# 374-380 Lonsdale Street, Melbourne

Planning Permit Application No. 2011/013331A

Figure 2 - Overlooking Diagram Typical Levels 34 - 50

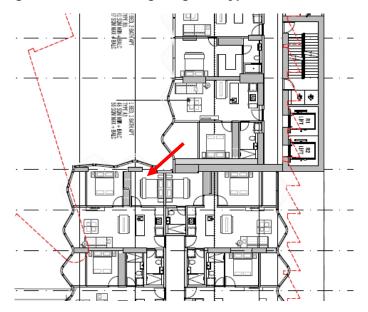
Council has identified an error on plan for the south west apartment second bedroom on levels 50 and 51. It appears that no window is provided for these apartments. This matter can be addressed by way of permit condition. Furthermore the Department's assessment has identified an internal interface concern between centrally located apartments from level 34 to level 50. These apartments are east facing and located between Grid Line F and GG on the plans (shown in figure 2 below).

The re-entrant corner of the development results in overlooking between these apartments and screening measures should be used or the layout of apartments redesigned to offset direct views between habitable rooms/terraces. This issue can be addressed by way of permit condition. The balance of the development is sufficiently setback or has been designed to appropriately interface with existing dwellings on adjacent sites.
